SOUTHERN CALIFORNIA EDISON  
TRANSMISSION AND DISTRIBUTION

Distribution Overhead  
Construction Standards  
(DOH)

**2019 — SECOND QUARTER ISSUE**

## Revision Summary

**Figure AP 336-1: Horizontal Inverted Omni-Rupter Switch, Line Dead-Ended Directly to Switch**

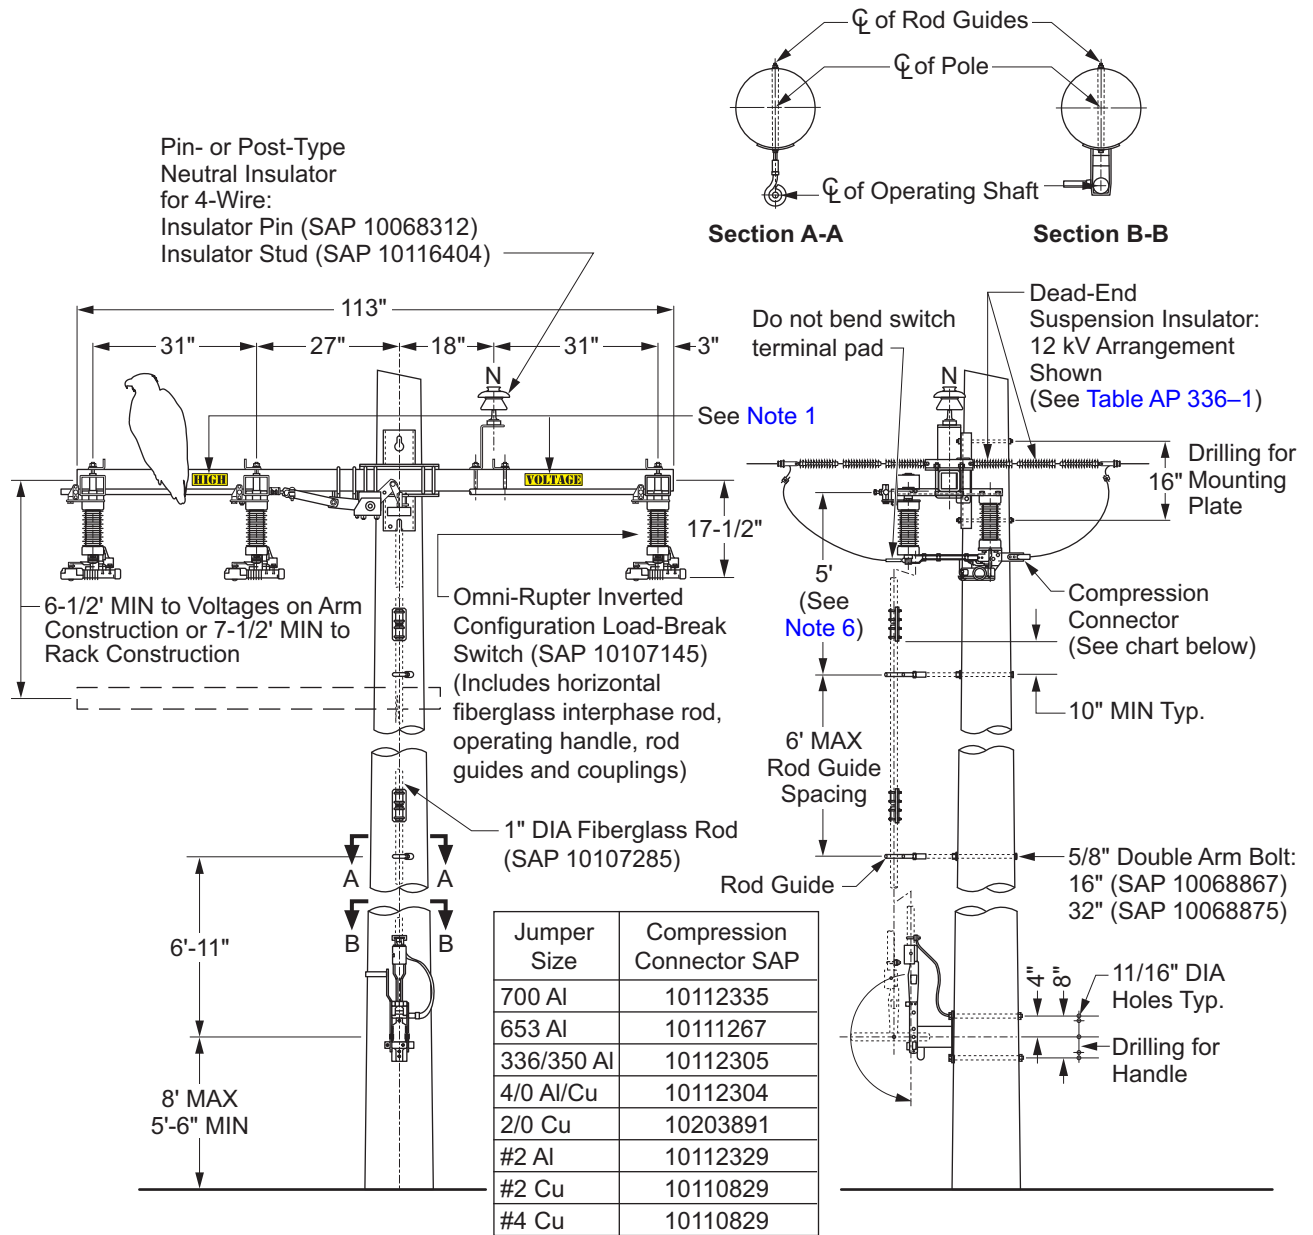
**What's Changed?** Updated Figure 336-1 to show increased amount of insulators. Added Insulator summary Table AP 336-1 for how many insulators to use.

**Figure AP 336-2: Horizontal Inverted Omni-Rupter Switch Below Line Arm, Utilizing Hughes Adapter**

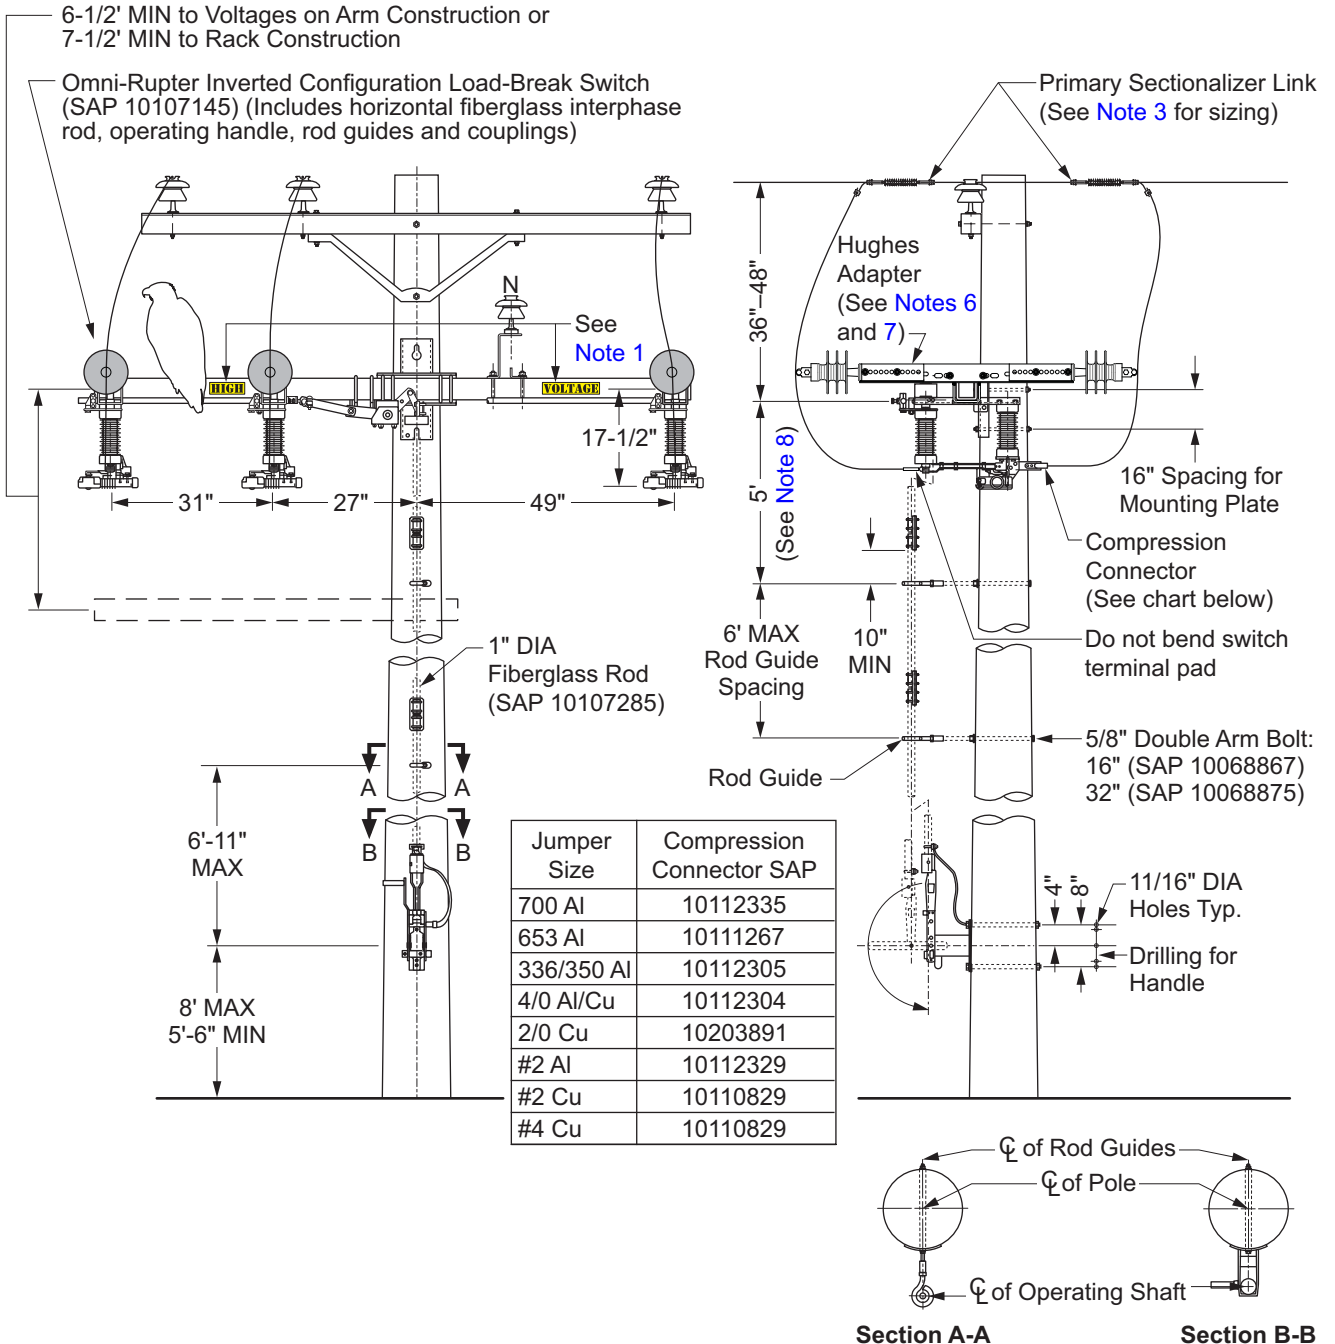
**What's Changed?** Revised Figure AP 336-2 to show proper placement of primary sectionalizing link.

Figure AP 336-5: Vertical Inverted Omni-Rupter Switch

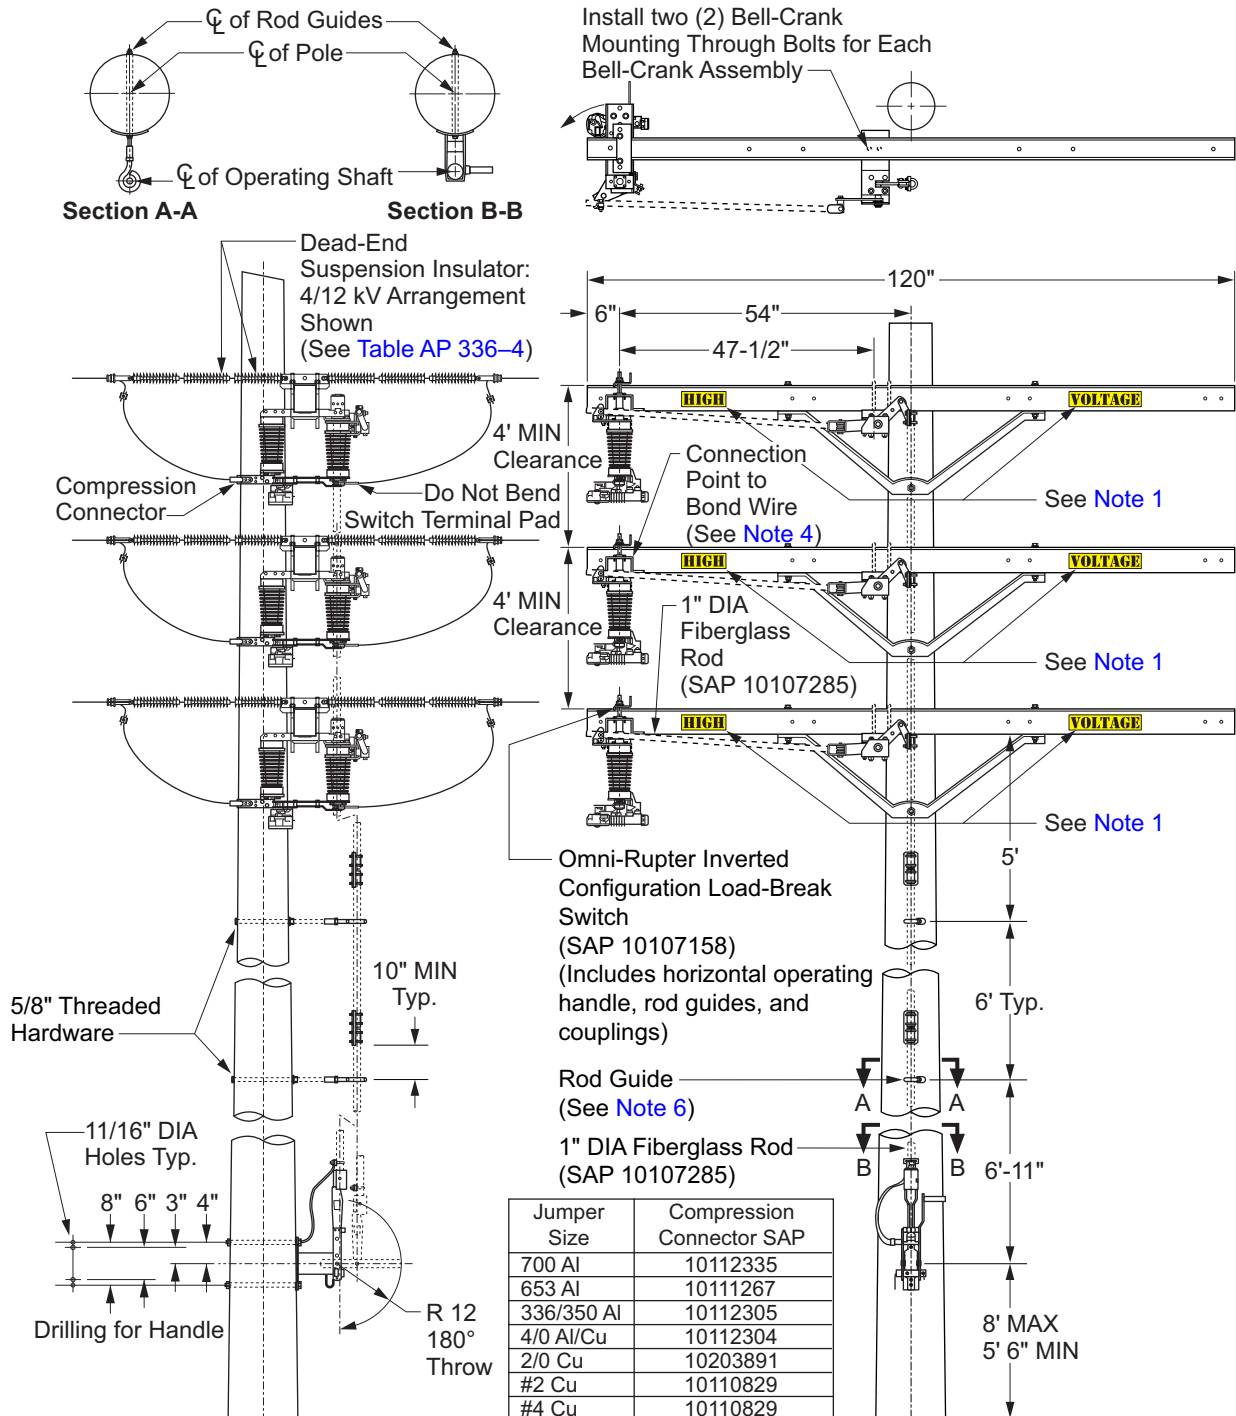
**What's Changed?** Updated Figure AP 336-5 to show increased amount of insulators. Added Insulator summary Table AP 336-4 for how many insulators to use.

**Figure AP 336-6: Horizontal Inverted 4-Pole Switch, for 4 kV Isolated Neutral Systems**

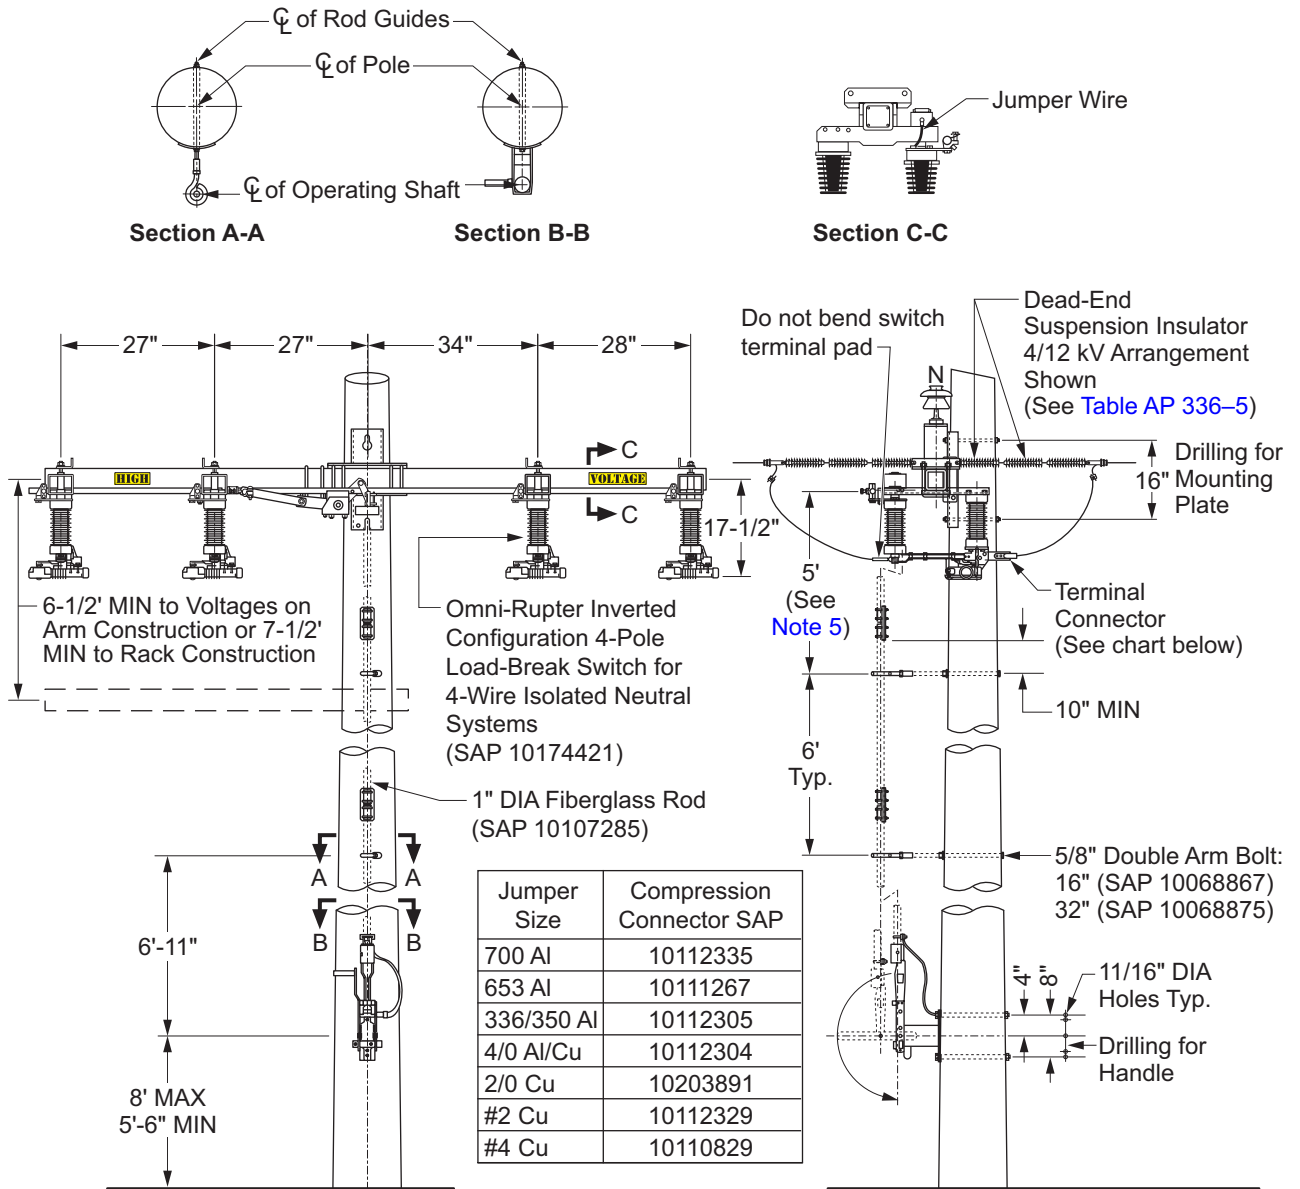
**What's Changed?** Updated Figure AP 336-6 to show increased amount of insulators. Added Insulator summary Table AP 336-5 for how many insulators to use.

Figure AP 337-2: Automated Horizontal Inverted Omni-Rupter Switch, Line Dead-Ended Directly to Switch

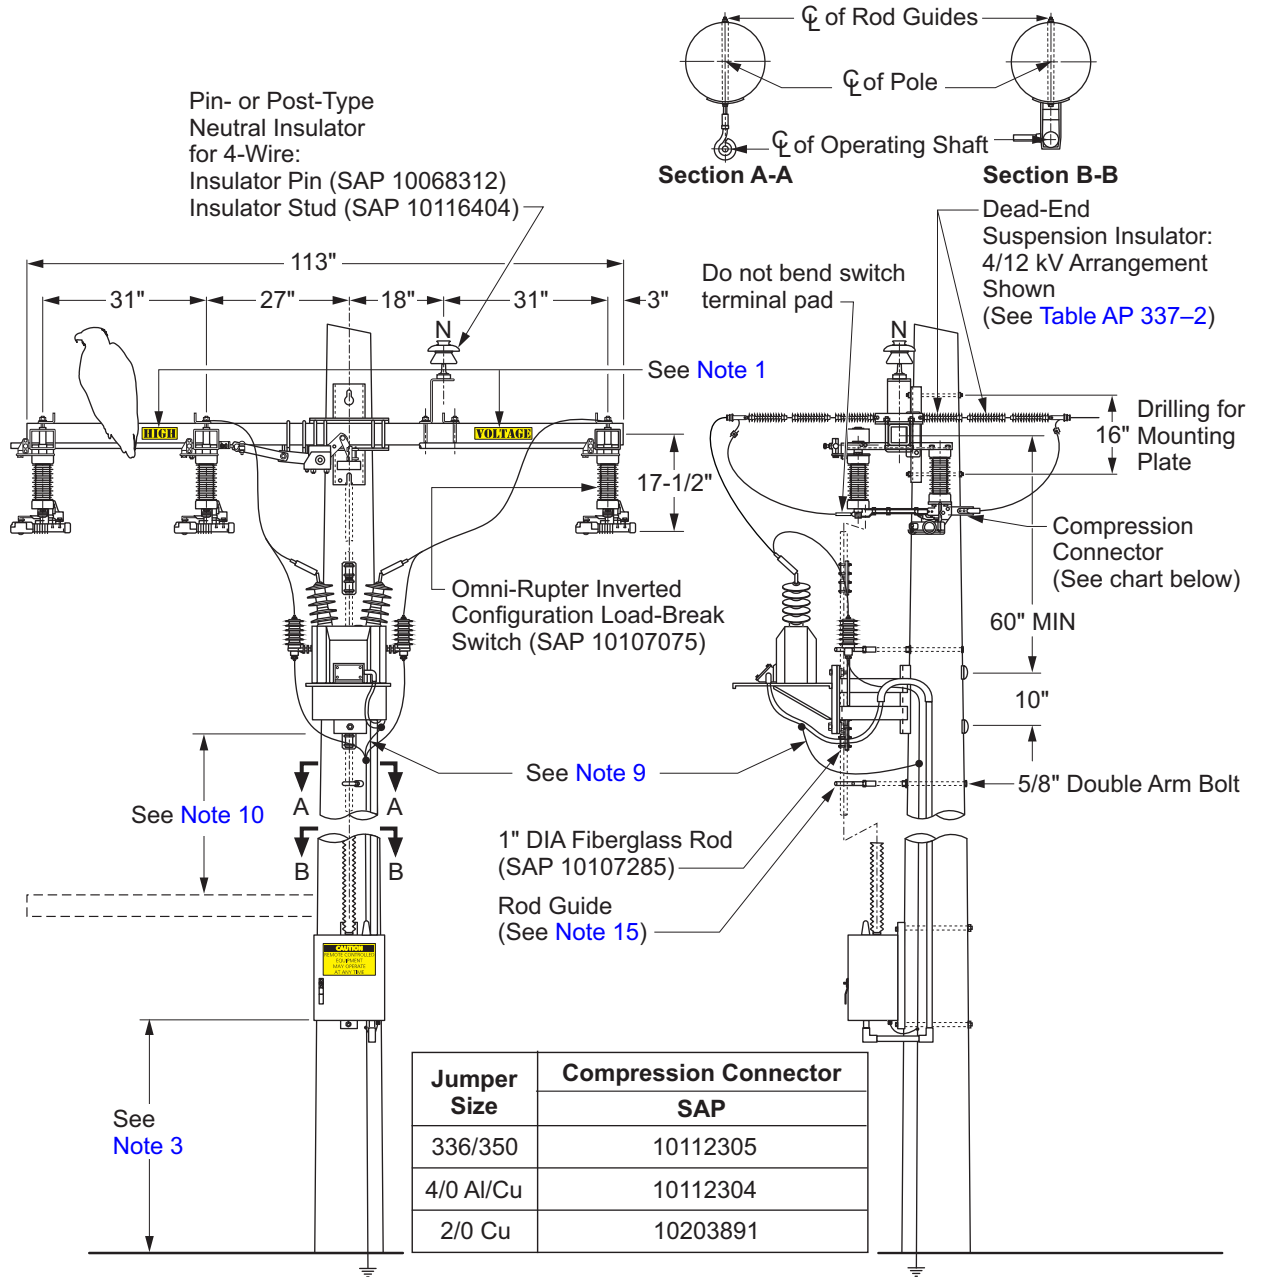
**What's Changed?** Updated Figure AP 337-2 to show increased amount of insulators. Revised note call-out numbers.

Figure AP 337-3: Automated Vertical Inverted Omni-Rupter Switch

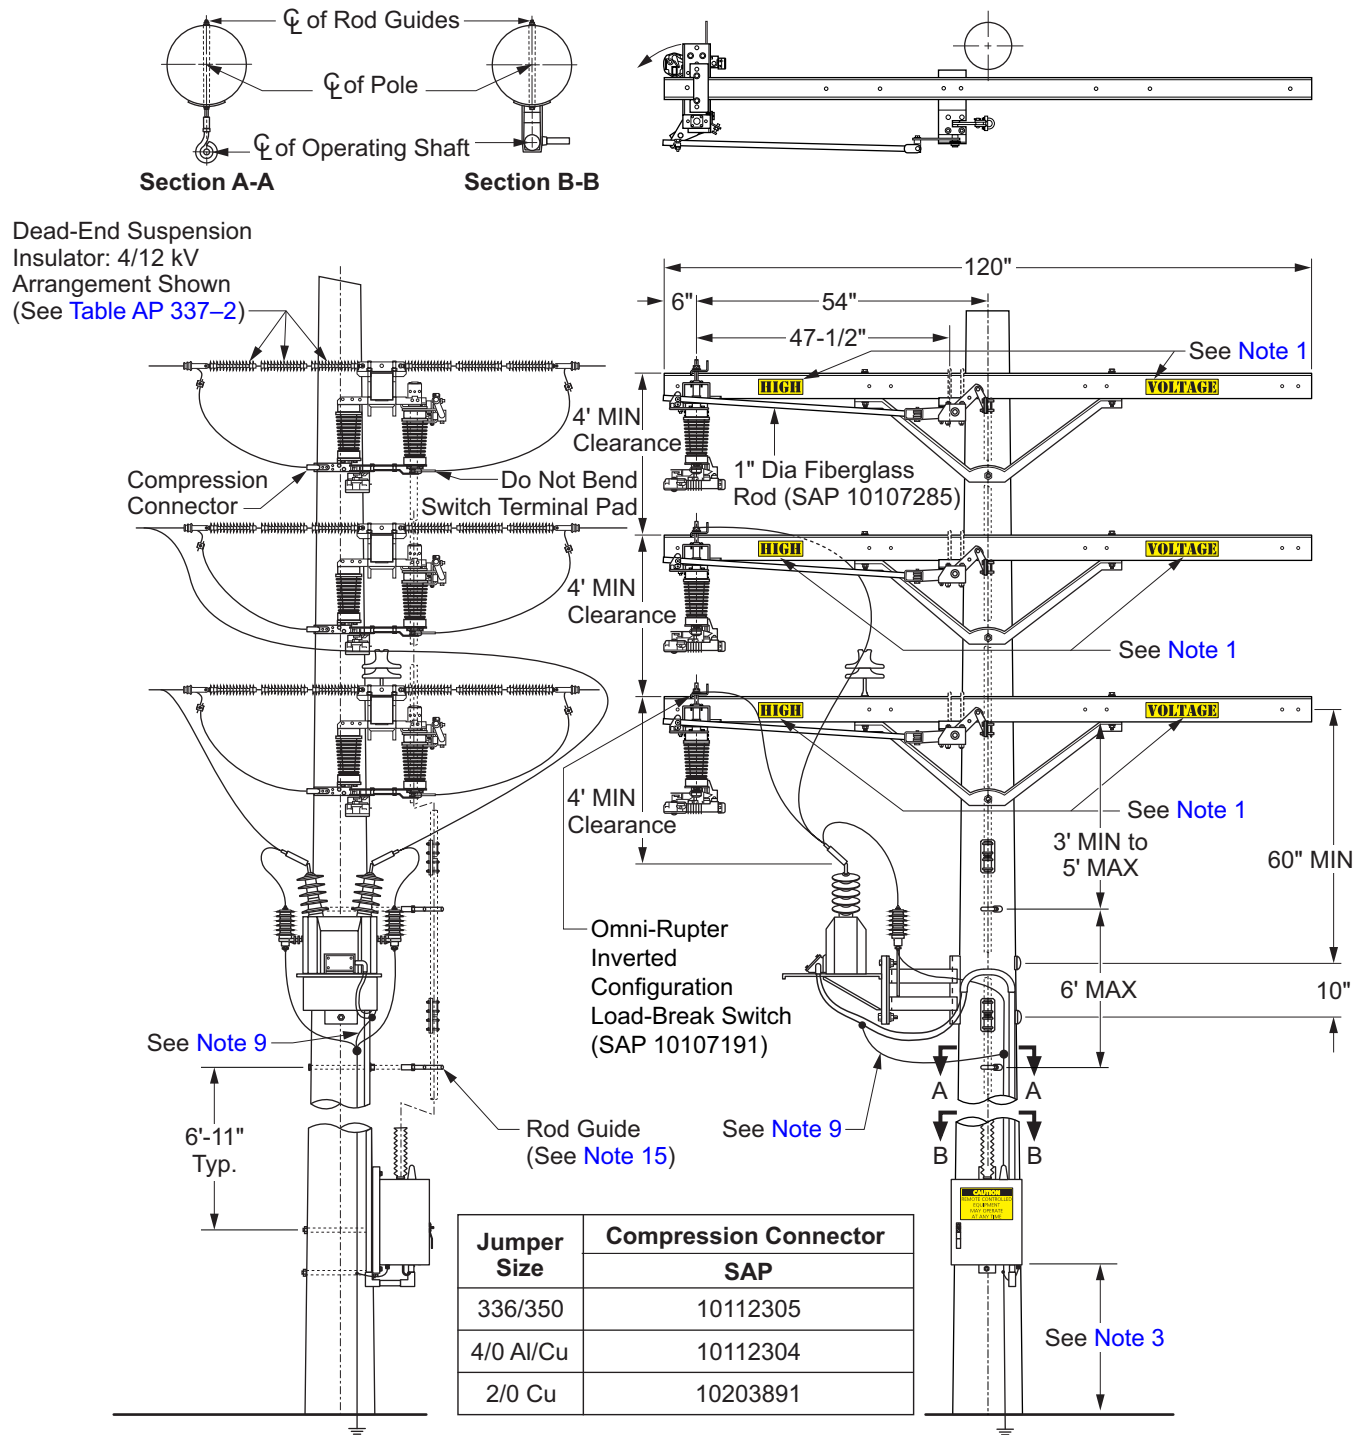
**What's Changed?** Updated Figure AP 337-3 to show increased amount of insulators. Revised note call-out numbers.
